Well Name: PURE GOLD MDP1 29-17 FED COM	Well Location: T23S / R31E / SEC 29 / SESE / 32.269773 / -103.7944639	County or Parish/State: EDDY / NM
Well Number: 176H	Type of Well: OIL WELL	Allottee or Tribe Name:
Lease Number: NMNM0281482A	Unit or CA Name:	Unit or CA Number:
US Well Number: 3001545781	Well Status: Drilling Well	Operator: OXY USA INCORPORATED

Notice of Intent

Sundry ID: 2640172

Procedure Description: OXY USA Inc. respectfully requests approval to amend the approved APD directional plan, drilling casing, cementing and mud programs. See the attached updated directional plan and drill plan for reference. Also note the HSU, pool change and well spacing on the attached C102 well plat.

Figure C] 4 – String – Un Cemented Annulus

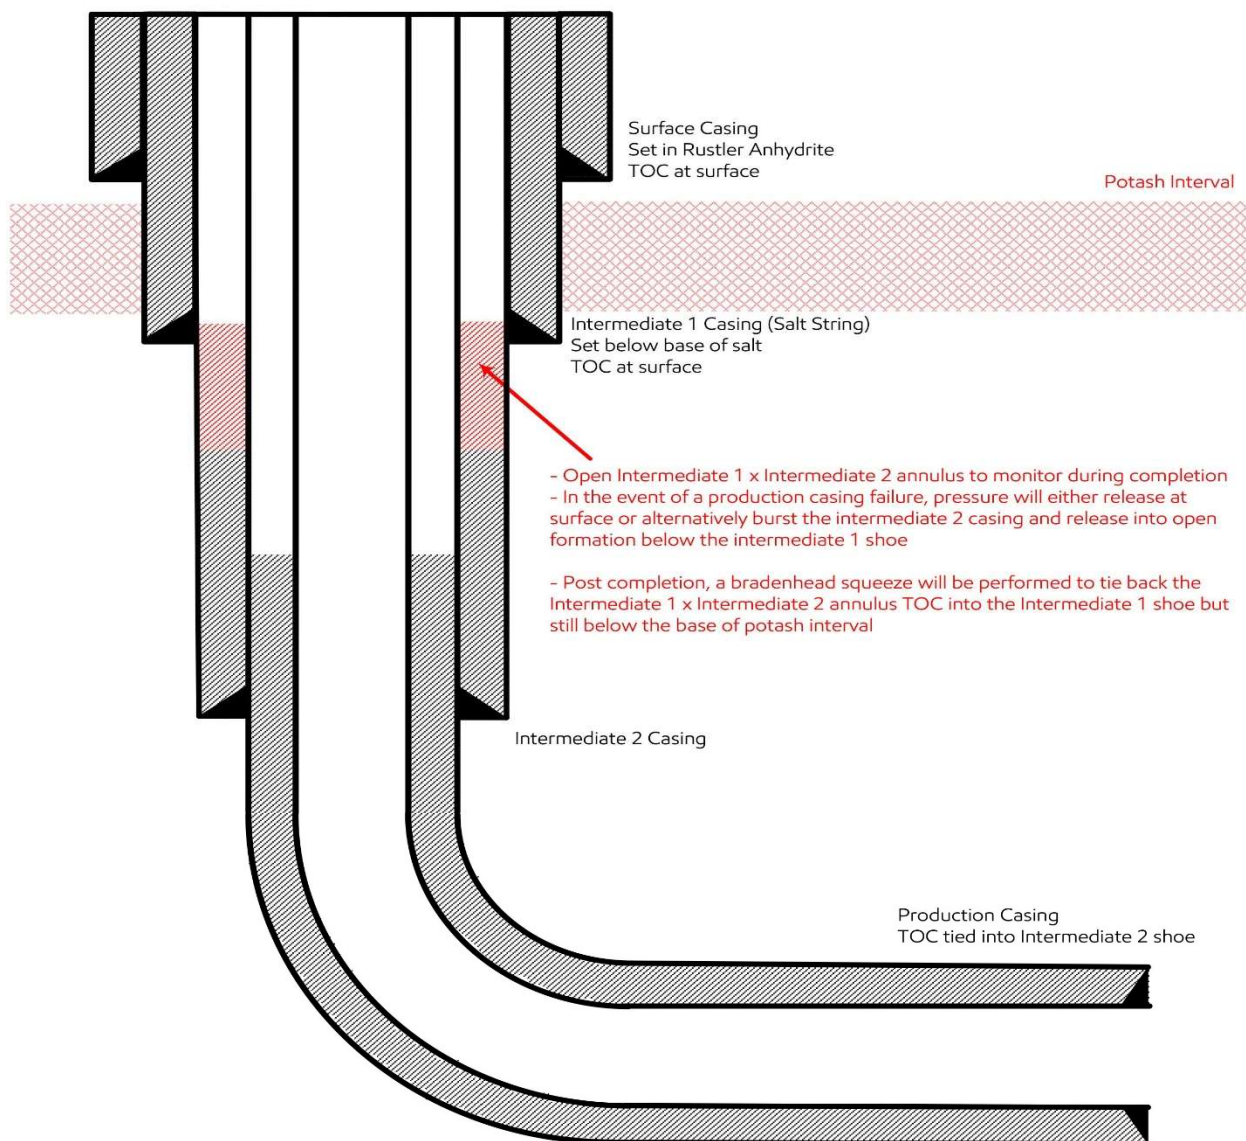
Operator has proposed to pump down the 9-5/8" X 7-5/8" annulus post completion. Operator must run Echo-meter to verify Cement Slurry top in the annulus. Submit results to the BLM. No displacement fluid shall be utilized at top of the cement slurry.

Operator has proposed an open annulus completion in R111P. Operator shall provide a method of verification pre-completion top of cement. Submit results to the BLM. Pressure monitoring device and Pressure Safety Valves shall be installed at surface on both the 7-5/8" X 9-5/8" annulus and the 9-5/8" X 5-1/2" annulus for the life of the well.

4-String Design – Open Int 1 x Int 2 Annulus
